# Technical Service BULLETIN

Title: **EXHAUST RATTLE**  
Models: '98 – '99 Land Cruiser

ENGINE  
EG005-00

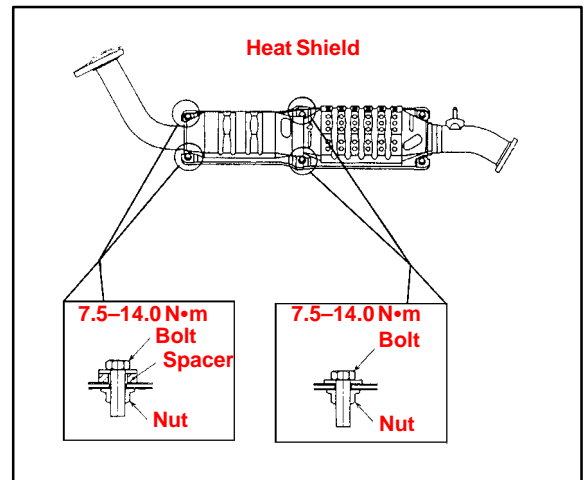
**Introduction** Some Land Cruiser vehicles may experience a rattle noise caused by the catalytic converter heat shield cracking around the bolts that secure them to the catalytic converter. A spacer has been added to reduce the possibility of the catalytic converter heat shield cracking.

PREVIOUS PART NUMBER	CURRENT PART NUMBER	PART NAME	QTY (EACH SIDE)
18435–50080	Same	Catalytic Converter Heat Shield	2
90179–06007	Same	Nut	4
90105–06081	91631–60618	Bolt	4
N/A	18449–74010	Spacer	2

1. Inspect the Catalytic Converter Heat Shields closest to the engine on both RH and LH cylinder banks for cracking around the 4 bolts.
2. If cracking is found, replace the Catalytic Converter Heat Shields, Bolts, Nuts, and install Spacers in specified quantities.
